**APPENDIX D**

**WCAP-1530, Revision 1 dated April 2001**

**"Surry Units 1 and 2 WOG Reactor Vessel 60-Year Evaluation Minigroup Heatup  
and Cooldown Limit Curves for Normal Operation"**

**Surry Units 1 and 2  
WOG Reactor Vessel 60-Year Evaluation Minigroup  
Heatup and Cooldown Limit Curves  
For Normal Operation**

Figure 3.1-1

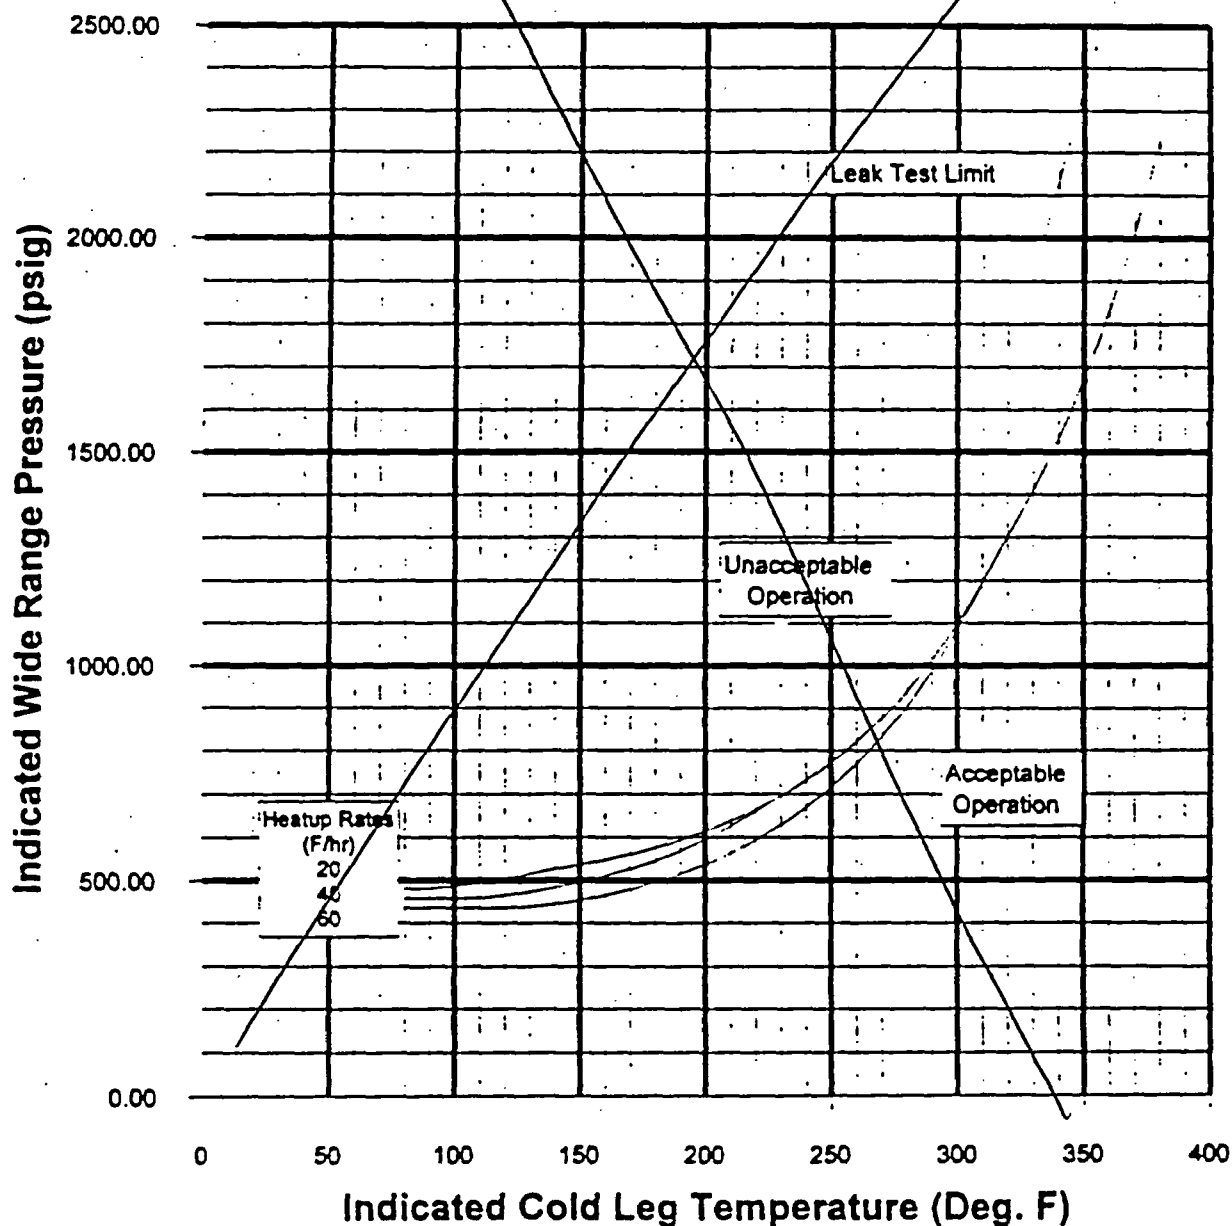
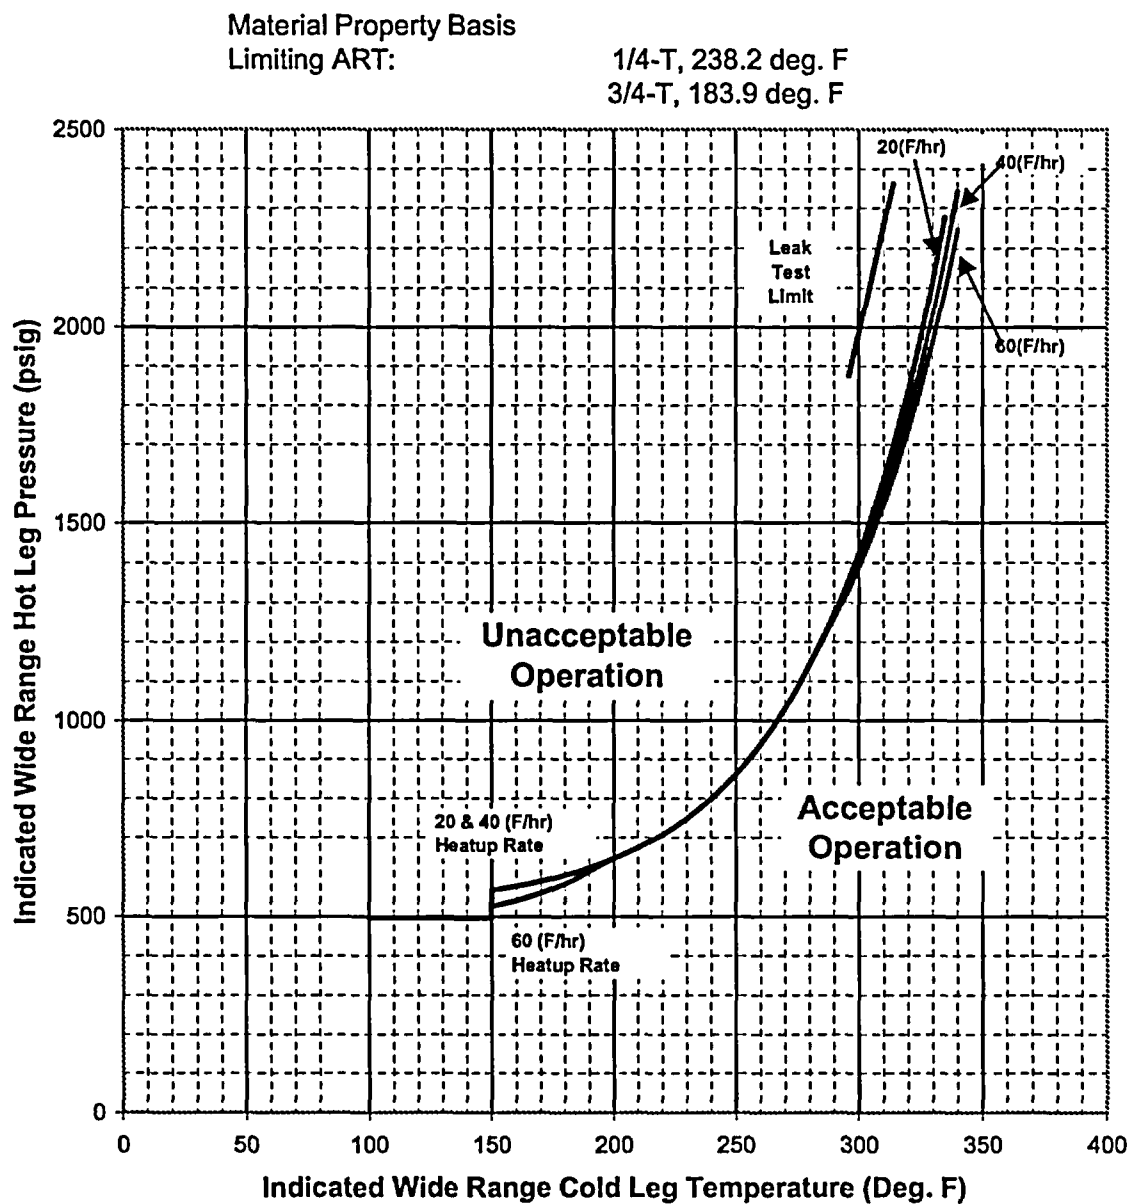
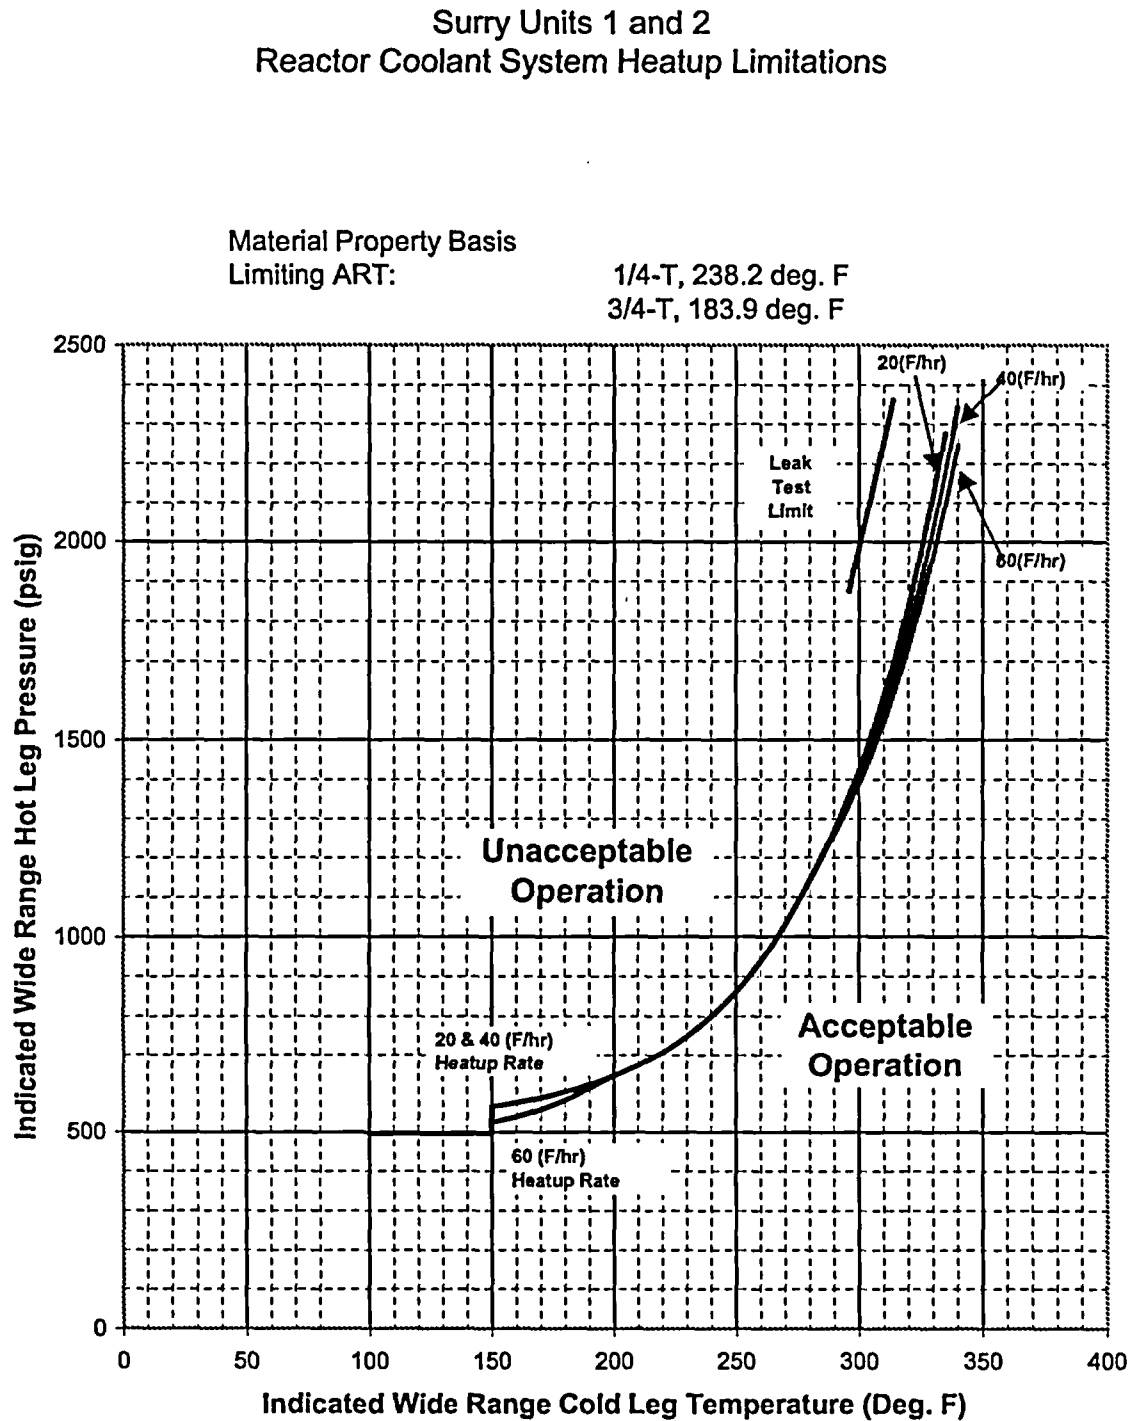
Replace w/ new Fig 3.1-1

The heatup limit curve, Figure 3.1-1, is a composite curve which was prepared by determining the most conservative case, with either the inside or outside wall controlling, for any heatup rate up to 60°F per hour. The cooldown limit curves of Figure 3.1-2 are composite curves which were prepared based upon the same type analysis with the exception that the controlling location is always the inside wall where the cooldown thermal gradients tend to produce tensile stresses while producing compressive stresses at the outside wall. The cooldown limit curves are valid for cooldown rates up to 100°F/hr. The heatup and cooldown curves were prepared based upon the most limiting value of the predicted adjusted reference temperature at the end of 28.8 EFPY and 28.4 EFPY for Units 1 and 2, respectively. The adjusted reference temperature was calculated using materials properties data from the B&W Owners Group Master Integrated Reactor Vessel Surveillance Program (MIRVSP) documented in the most recent revision to BAW-1543 and reactor vessel neutron fluence data obtained from plant-specific analyses.

Figure 3.1-2 : Surry Units 1 and 2 Reactor Coolant System Cooldown Limitations (Cooldown Rates up to 100°F/hr) Applicable for the first 47.6 EFPY for Unit 1 and 48.1 EFPY for Unit 2 (Including Margins for Instrumentation Errors)

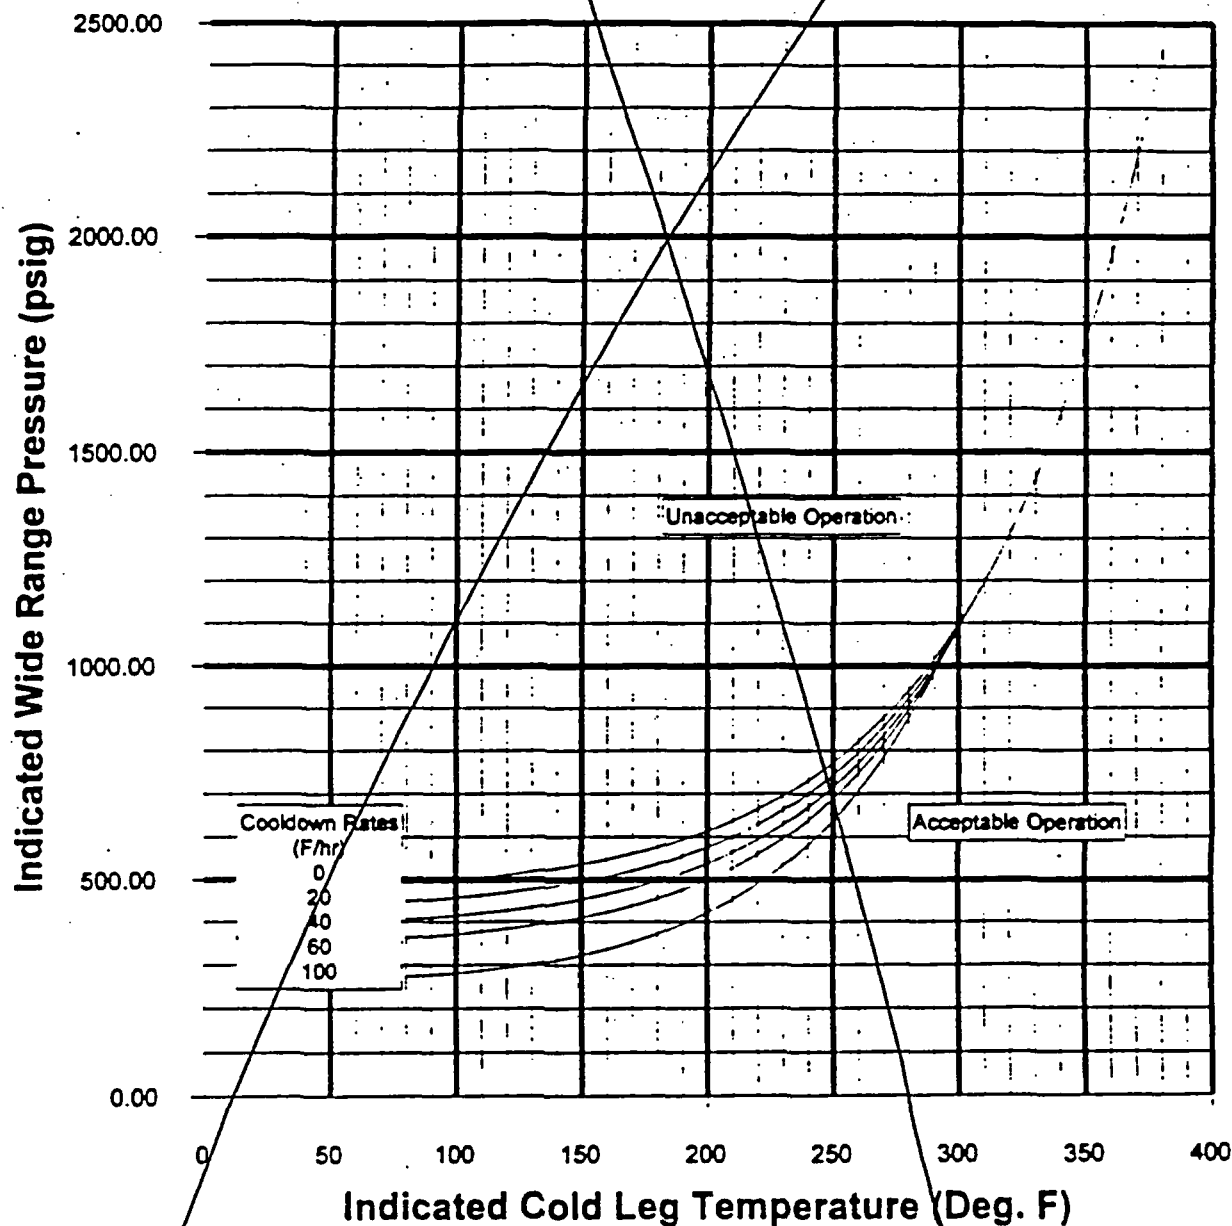
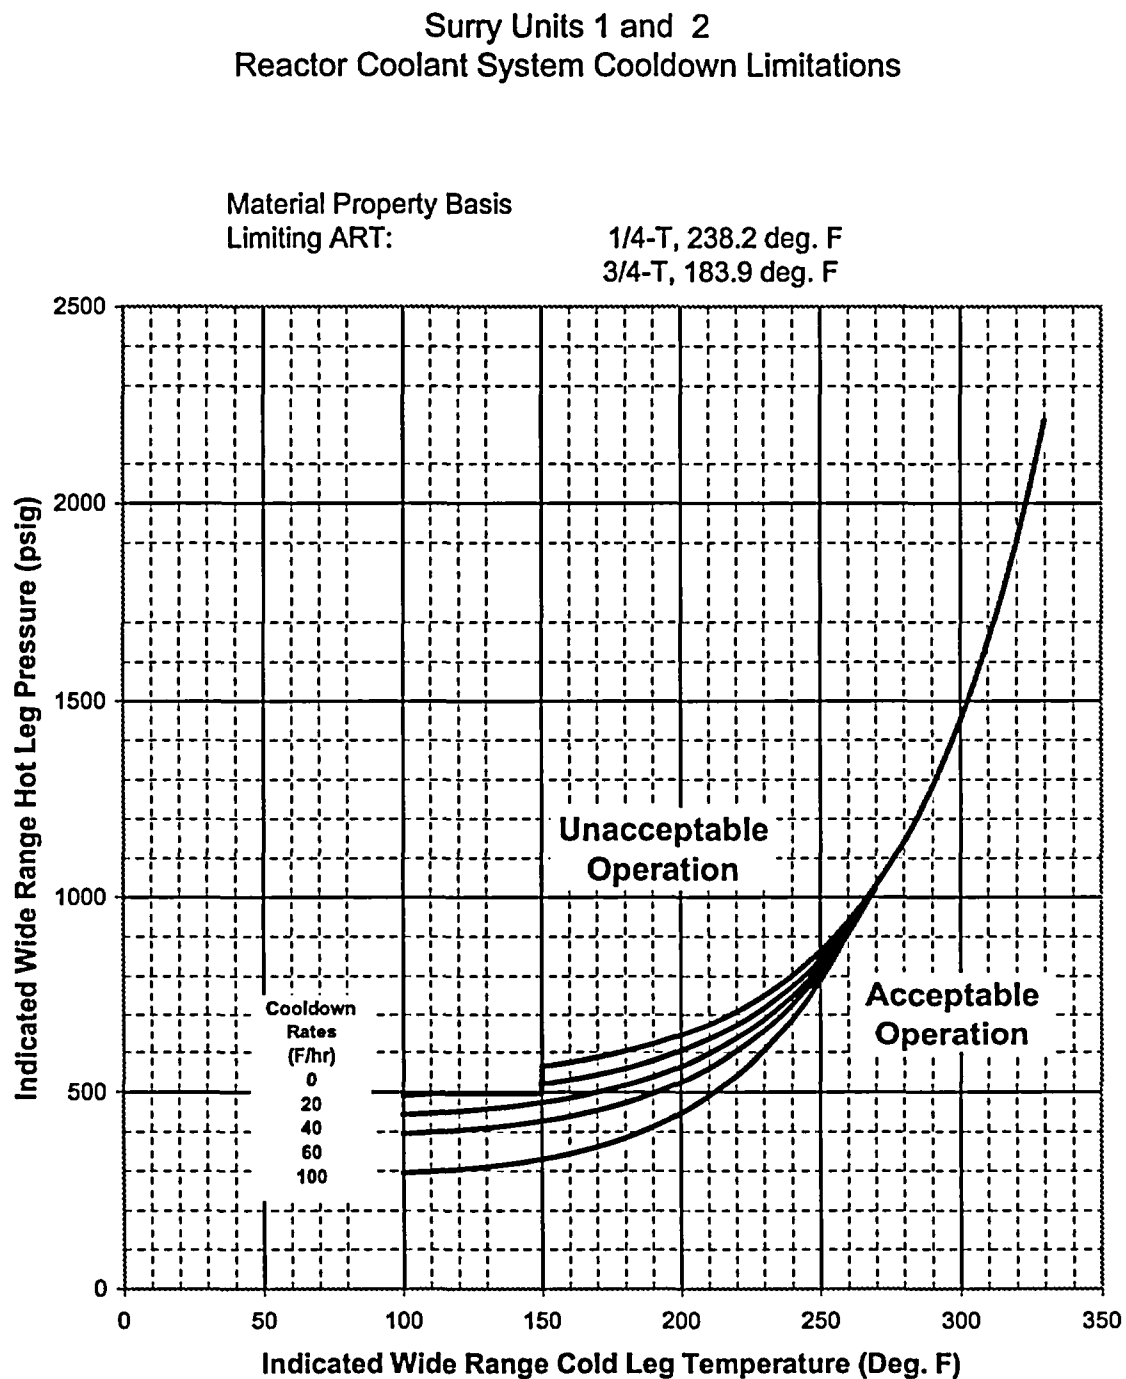
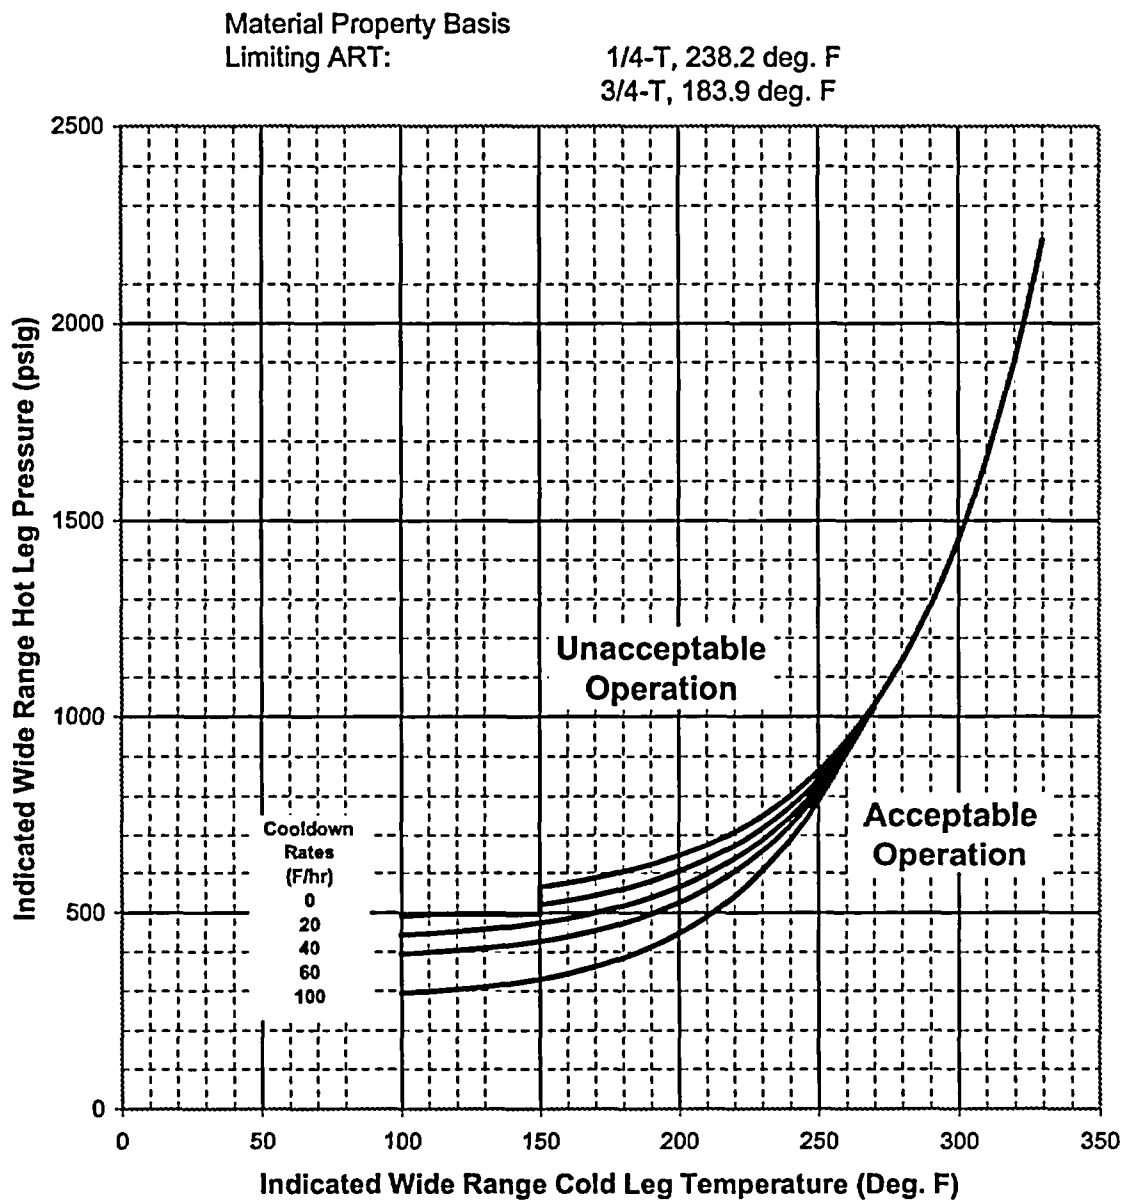
Replace w/new  
Fig 3.1-2
